CITY AIRPORT DEVELOPMENT PROGRAMME (CADP)

**ENVIRONMENTAL STATEMENT
SECOND ADDENDUM (ESSA)
AND OTHER CLARIFYING
INFORMATION**

28 May 2014

London Borough of Newham's Regulation 22 Letter, 23rd May 2014

Figure 2.1-Comparison between LCY SIDS and Actual Mean Departure Tracks

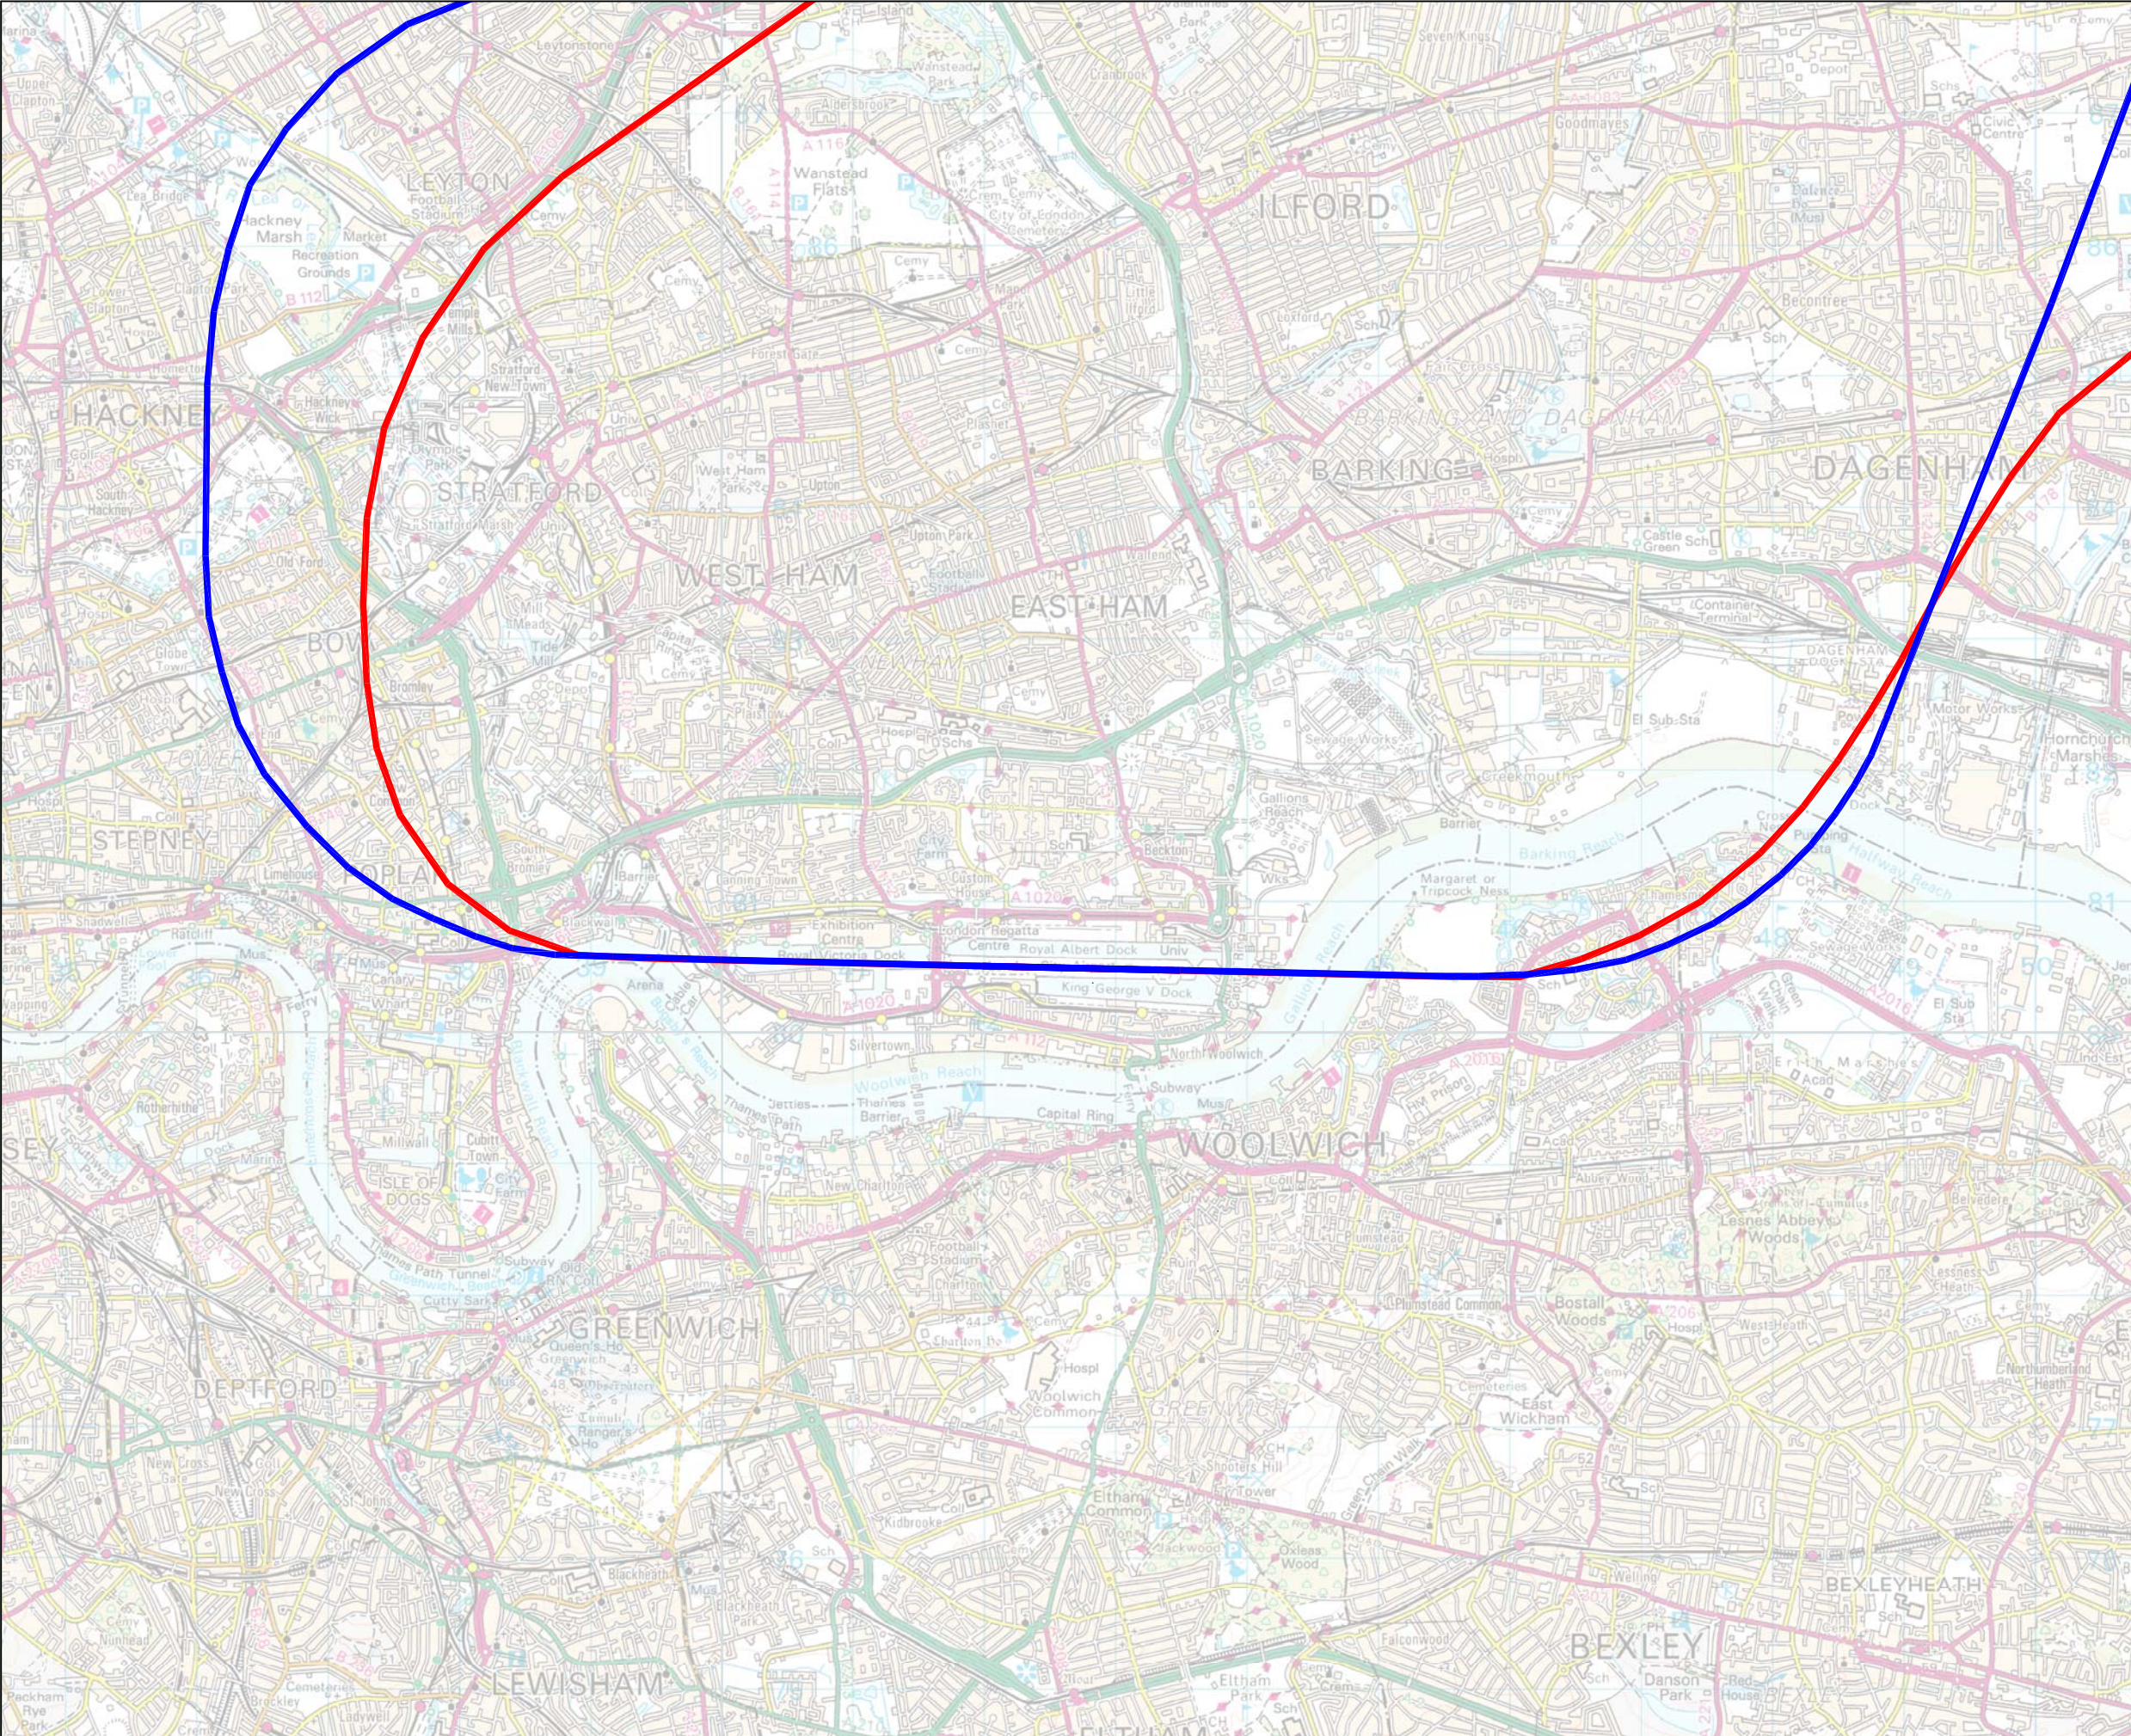
1) In LCA's Regulation 22 response (10th March 2014), Figure 4.2.1 showed how actual departure tracks differ from the standard instrument departure routes (SIDs) at London City Airport. The noise contours for the Environmental Statement and also those produced annually for sound insulation assessment purposes are based on the London City Airport's published SIDs. Although it is accepted that for the key contours (57 dB and higher), the differences are expected to be small, we request that contours are generated using the actual tracks flown from London City Airport aircraft rather than using the London City Airport published SIDs.

- 2.4 Figure 2.1 within Appendix 2.1 provides a comparison between the actual departure tracks followed by aircraft departing from the Airport on both runways with the Standard Instrument Departure Routes (SIDs) used in Chapter 8 of the ES. The figure shows the mean track and an assumed dispersion around the mean track.
- 2.5 The mean track has been determined from an analysis of three individual weeks or seven day periods of departure track data, both for Runway 09 and Runway 27, derived from the Airport's noise monitoring and flight track keeping system which is described in the ES and Section 4 of

the ESA (March 2014). The dispersion model is based on the same assumptions as used and presented in Chapter 8 of the ES. These assumptions are found to provide a reasonable match with the actual dispersion pattern at the Airport within the zones defined by the noise contours.

SCHEMATIC LAYOUT OF CONTRACTORS FACILITIES AND ACCESS

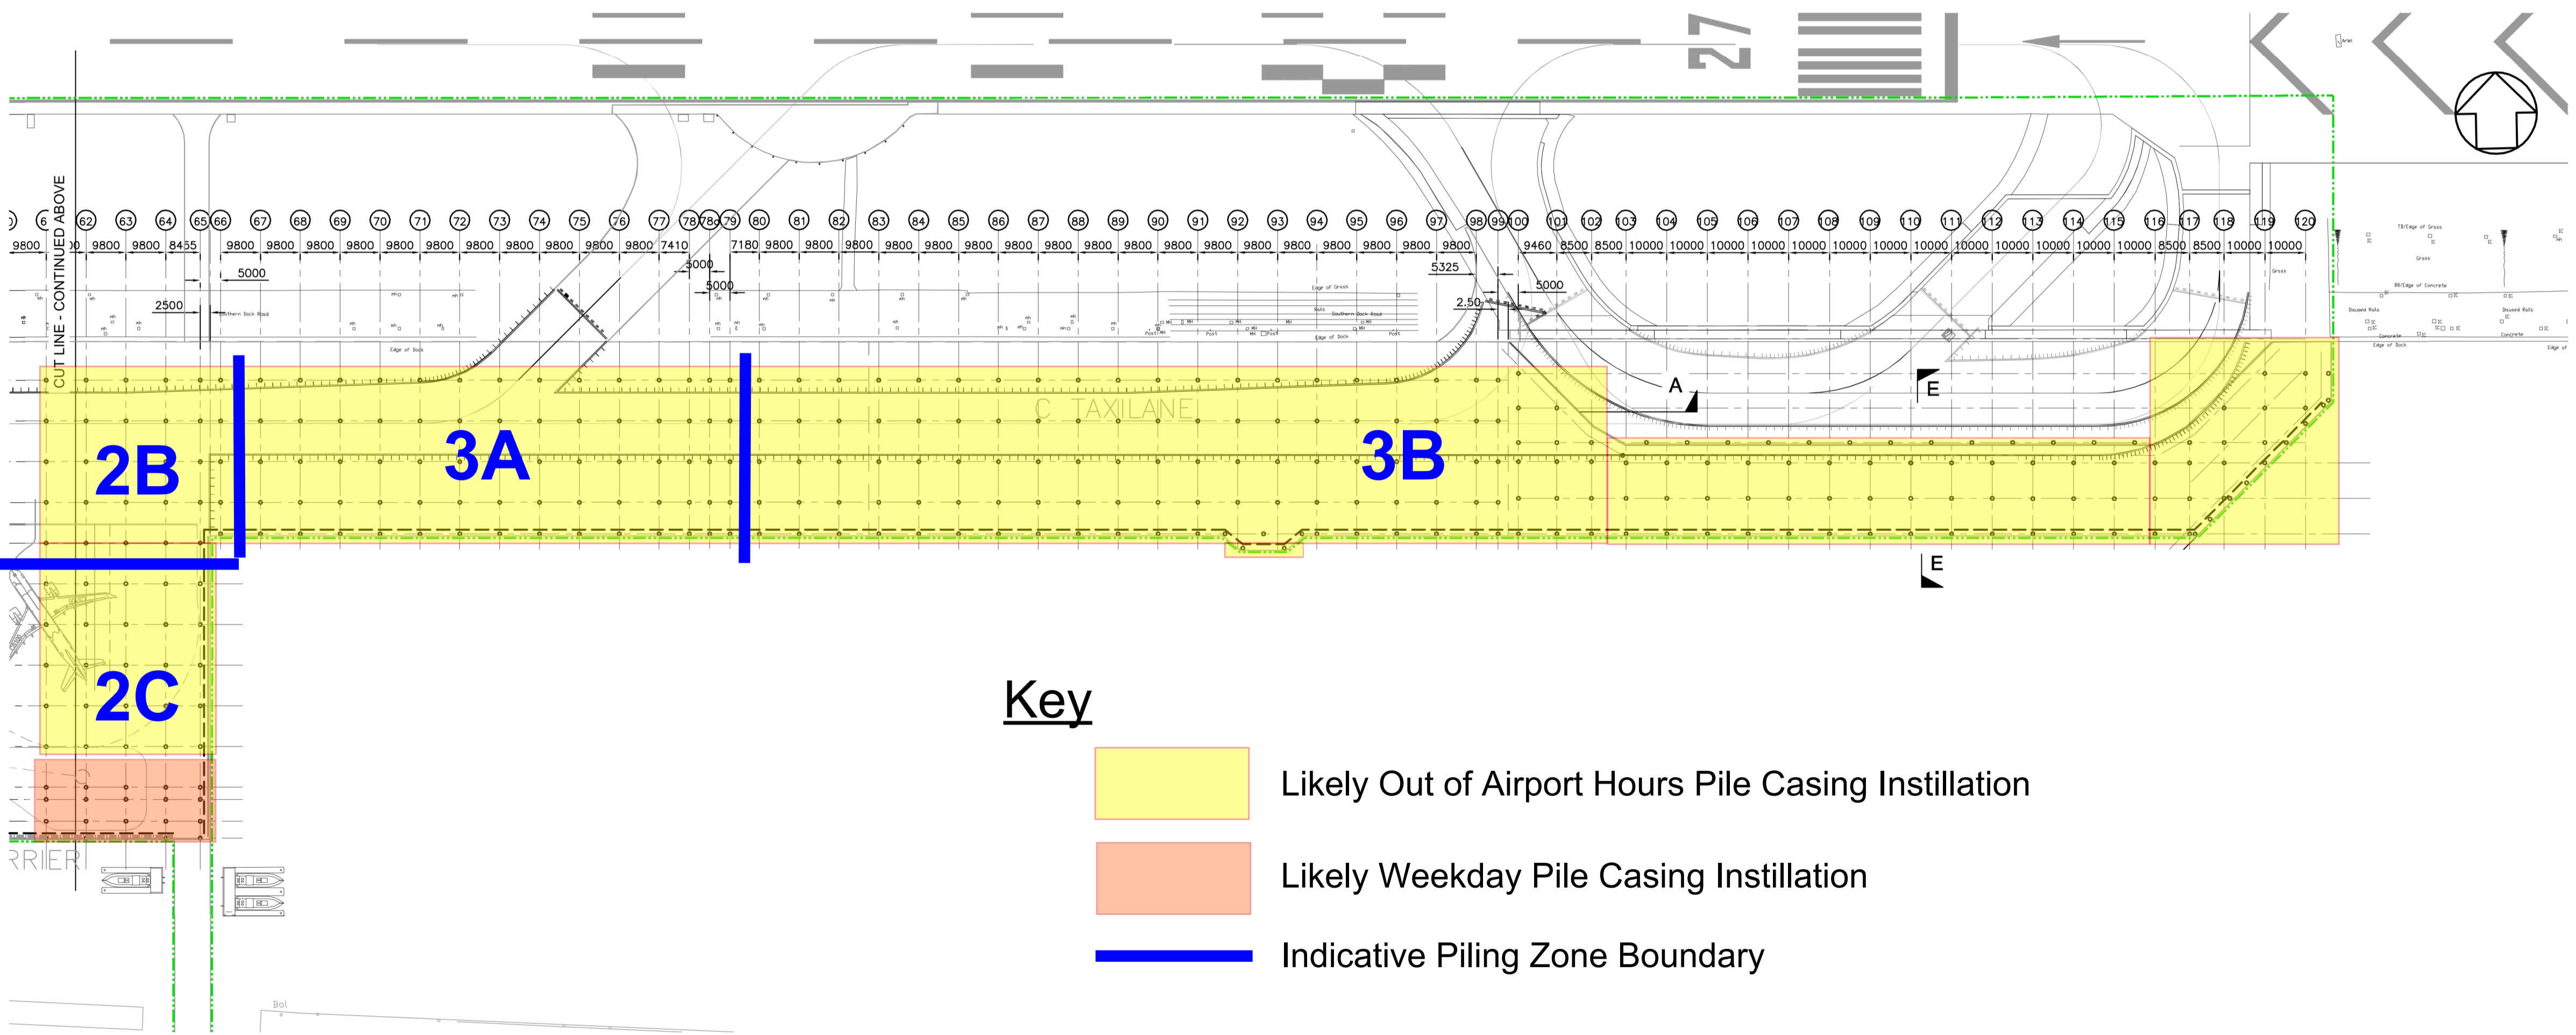
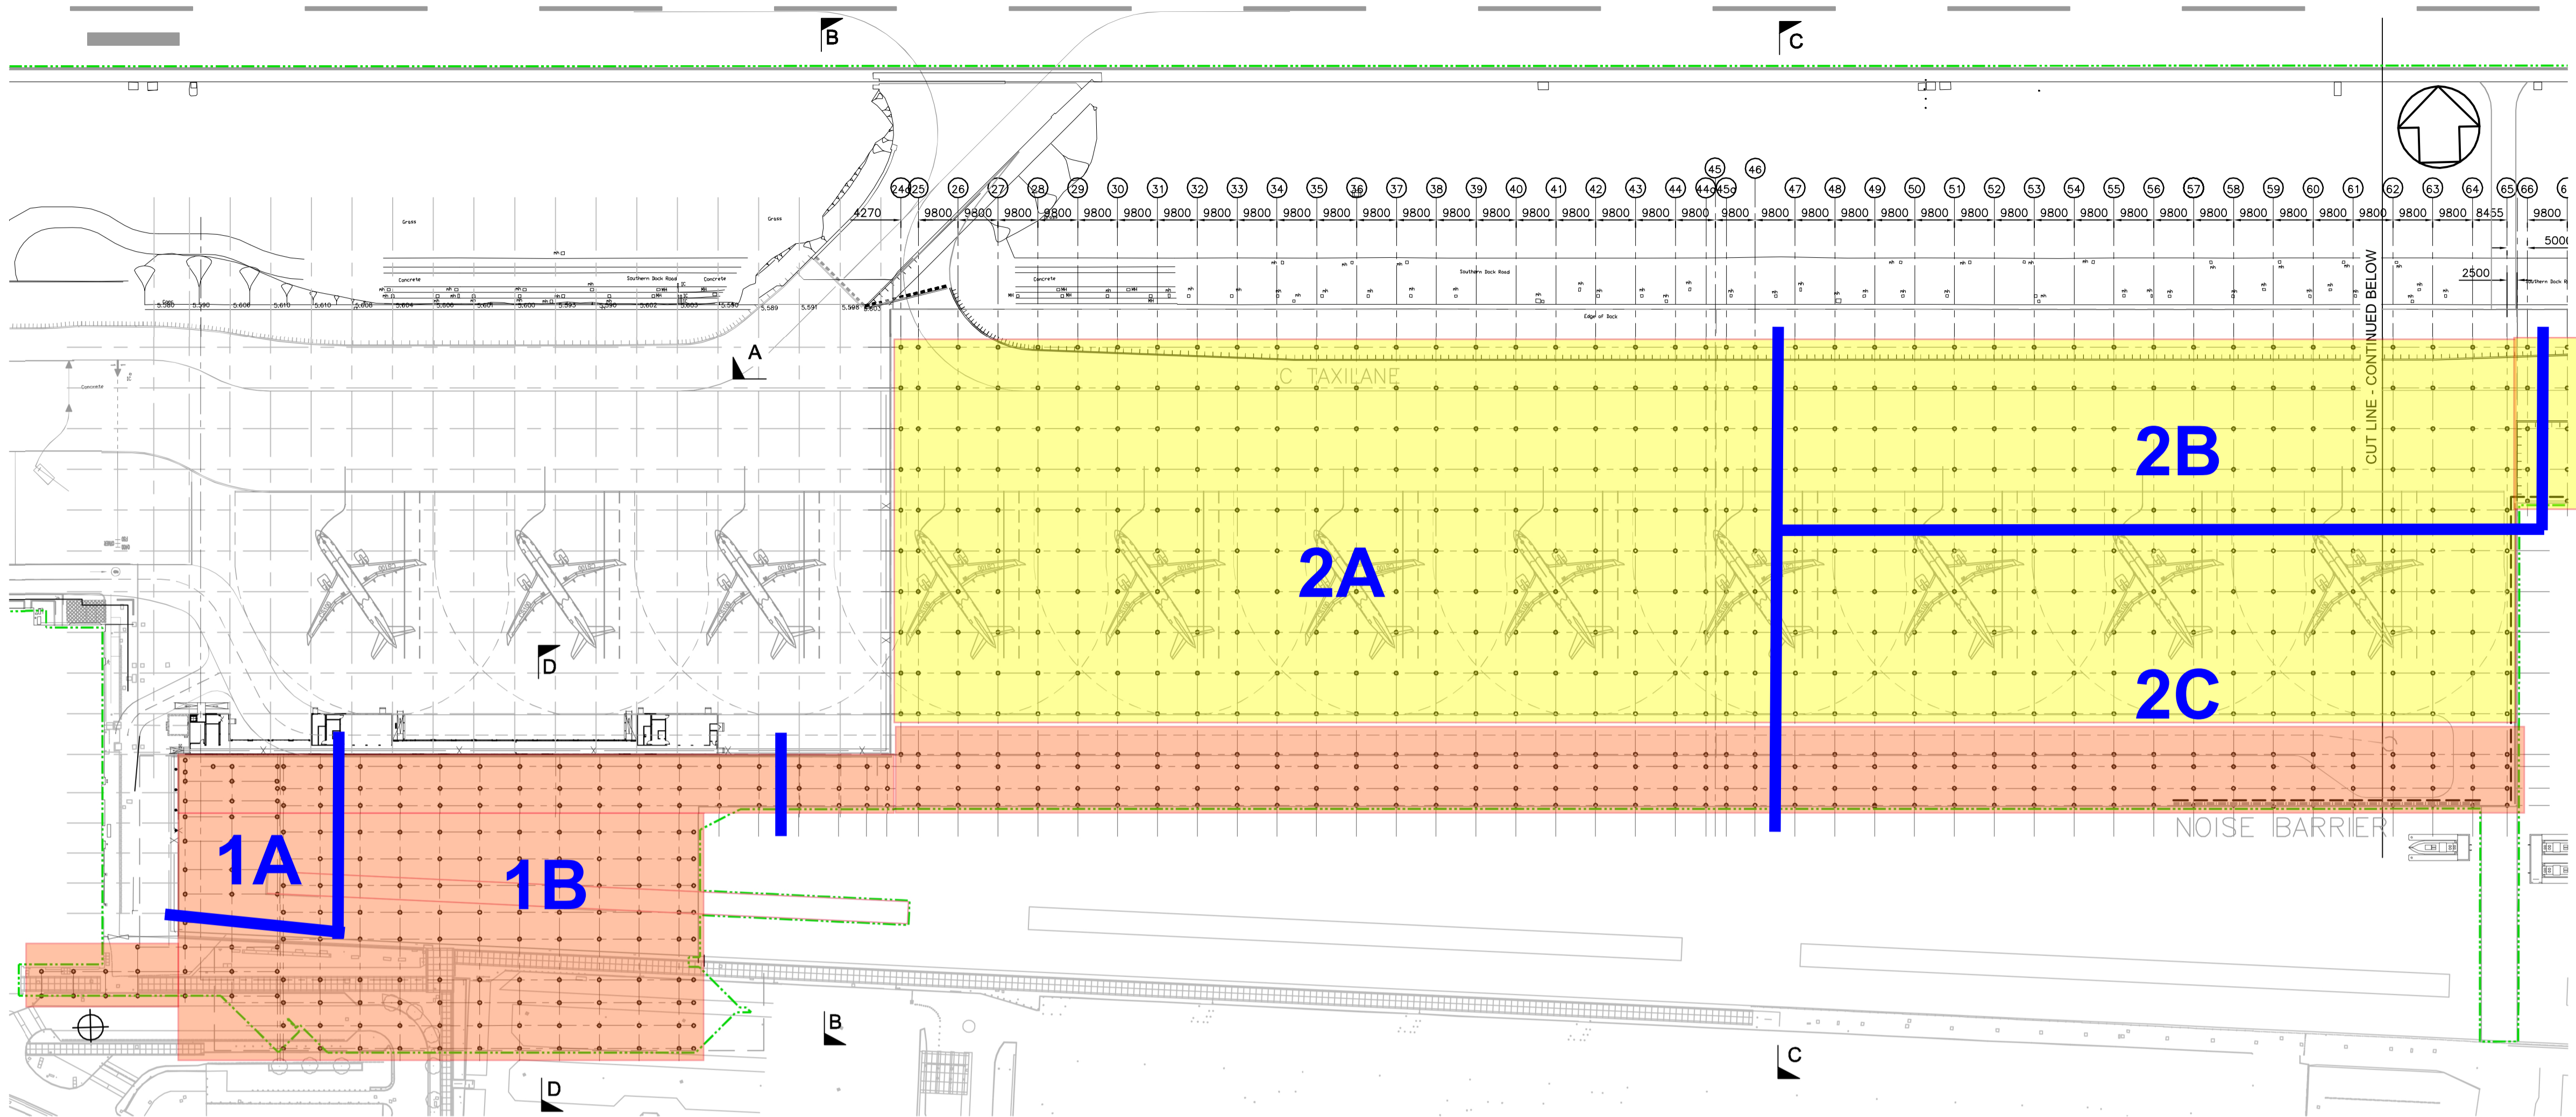
4) It is not clear what method has been adopted to assess the haul road. However should a BS5228:2009 approach have been taken, these noise levels should be added to the noise from the construction plant assessments when evaluating significance, particularly if the site routes will be used purely by construction vehicles. If not, an assessment based on changes in overall road traffic noise is more appropriate.

- 3.3 Appendix 3.1 includes a figure titled 'Schematic Layout of Contractors Facilities and Access' (Figure 6.9 extracted from Chapter 6 of the ES) which shows the routes for construction traffic by road and barge. The haul road will be used at various times of the day and night.

BAP confirms that the haul road has been added to the noise model and therefore added to the noise from the construction plant assessments.
